SHOP DRAWING

CLIENT : DELHI INTERNATIONAL AIRPORT LIMITED
PROJECT : NEW ATCT
PROJECT CONSULTANT: Engineering Design and Research Center L&T Construction (EDRC)
INSTALLED AND SUPPLIED BY: MMA TECHNOLOGIES PVT LTD

TITLE: ARFF5 MEGADOOR 8760 X 4988 (RS7)
SCALE 1:1
DRAWING No. DIAL-LT-Q-PTB-A-HSRS-ARFF5-01
SHEET:
PROJECTION FIRST ANGLE
SIZE A3
REV C
RELEASED FOR ☐ PRELIMINARY ☐ TENDER ☐ INFORMATION ☑ APPROVAL ☐ CONSTRUCTION

TITLE: ARFF5 MEGADOOR 5800 X 5360 (RS6)
SCALE 1:1
DRAWING No. DIAL-LT-Q-PTB-A-HSRS-ARFF5-02
PROJECTION FIRST ANGLE
SIZE A3
REV 0
SHEET:
RELEASED FOR ☐ PRELIMINARY ☐ TENDER ☐ INFORMATION ☑ APPROVAL ☐ CONSTRUCTION

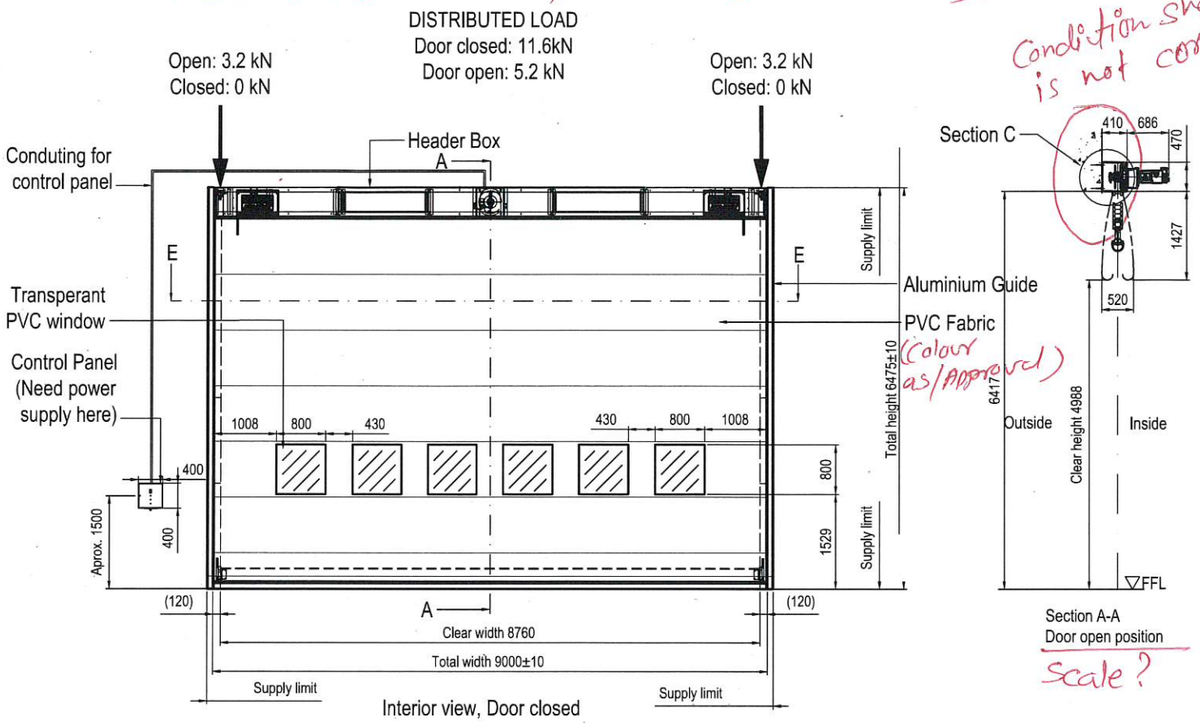
• Add cross section for both (open & close) conditions

Condition shown is not correct. Update detail

• Add title of plan and show in elevation

Scale not correct

• Mention correct scale for all details

• Electrical observation attached in mail.

• Previous given comments are not fully incorporated in shop drawings. Please comply.

Update format

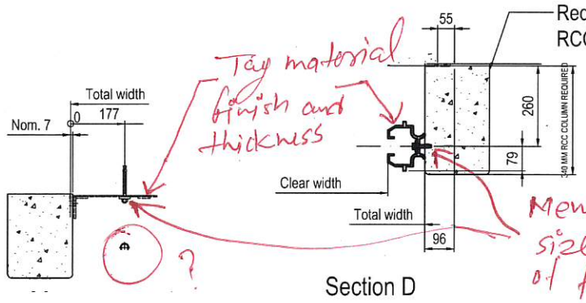
Scale not correct please Update

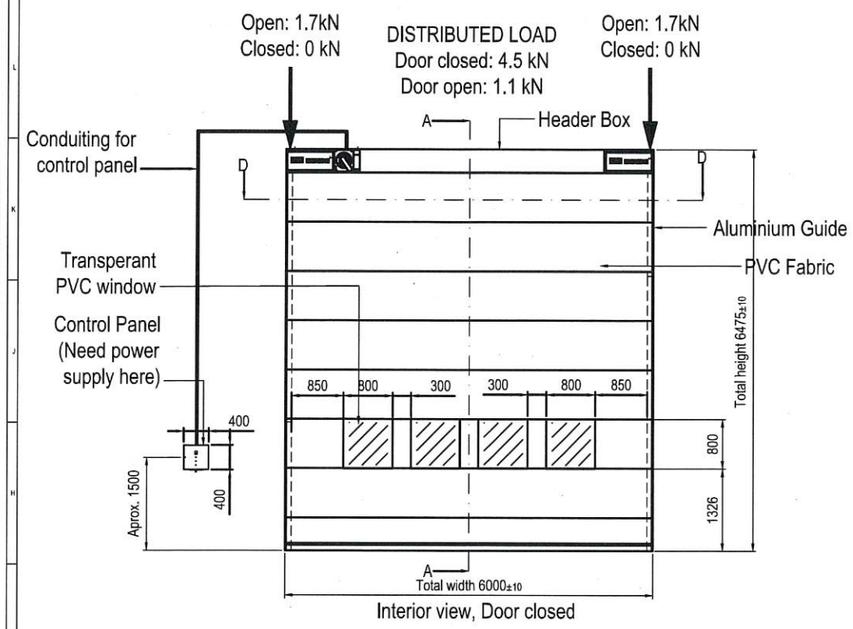
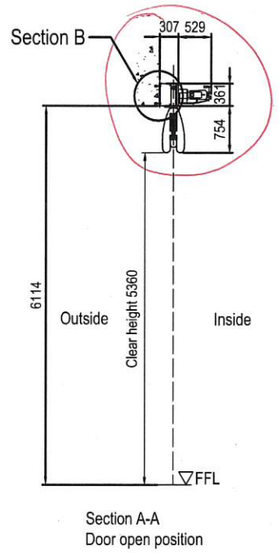
Drawing no. not correct. Update drawing no.

Please refer general comments provided on first drawing

Update format correctly

TITLE: ARFF4 MEGADOOR 8760 X 5400 (RS7)
SCALE 1:1
DRAWING No. DIAL-LT-Q-PTB-A-HSRS-ARFF4-01
SHEET:
PROJECTION: DIRECT METHOD
SIZE A3
REV 0
RELEASED FOR: ☐ PRELIMINARY ☐ TENDER ☐ INFORMATION ☑ APPROVAL ☐ CONSTRUCTION

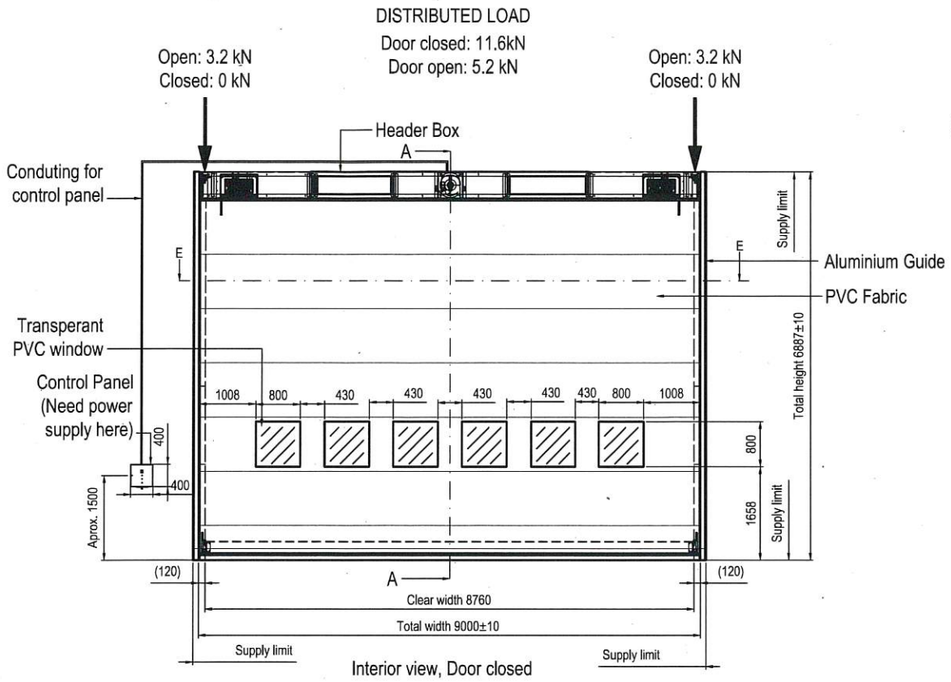
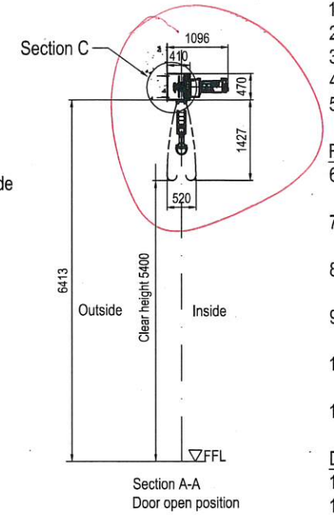
Drawing no. not Correct, Update it

Please refer general comments provided on 1st drawing

TITLE: ARFF4 MEGADOOR 5800 X 5400 (RS6)
SCALE
SCALE
DRAWING No. DIAL-LT-Q-PTB-A-HSRS-ARFF4-02
SHEET:
PROJECTION FIRST ANGLE
SIZE A3
REV 0
RELEASED FOR ☐ PRELIMINARY ☐ TENDER ☐ INFORMATION ☑ APPROVAL ☐ CONSTRUCTION

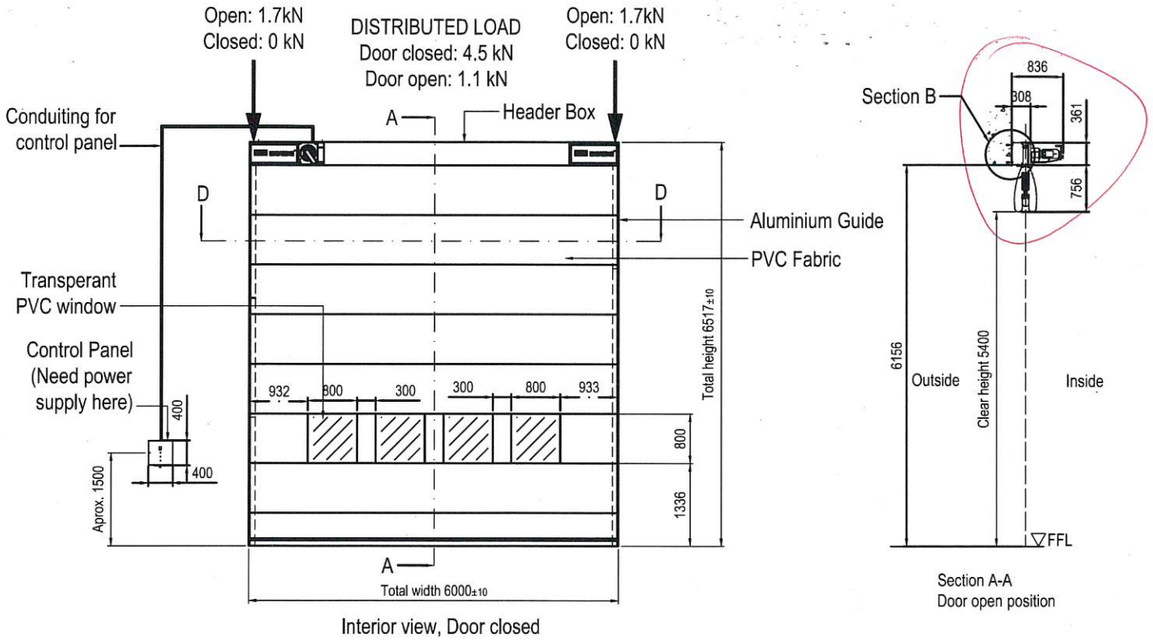
Please refer general comments provided on 1st drawing
